## SERVICE BULLETIN

ENGINE - DIFFUSER AND COMBUSTION GROUP - REPLACE A NO.4 BEARING COMPARTMENT TUBE  
BRACKET (CP 5756) - CATEGORY CODE 4 - MOD.ENG-72-0072

V2500-ENG-72-0072

CLIPPING POINT 5756  
Fig.1 Sheet 1 of 2

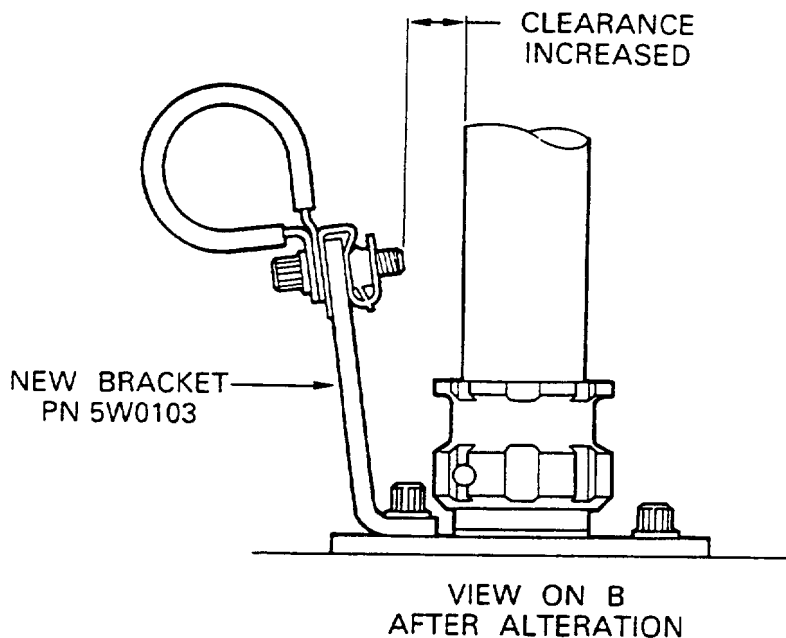
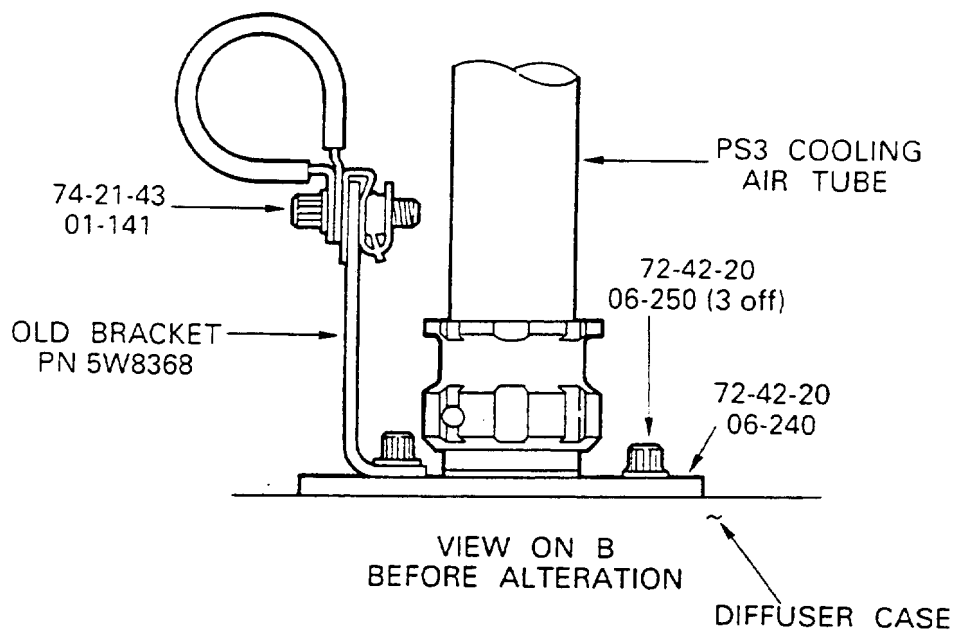
Insufficient clearance may exist between the bolt at the clipping point 5756 and PS3 cooling air tube.

(a) The bending angle of the bracket is slightly changed.

(b) The thickness of the new bracket is increased from 0.047in. (1,2 mm.) to 0.063in. (1,6 mm.)

- (1) Remove 5W8368, Bracket (72-42-20, 06-255), refer to Figures 1 and 2.

- (1) Install 5W0103 Bracket (72-42-20, 06-255), refer to Figures 1 and 2.
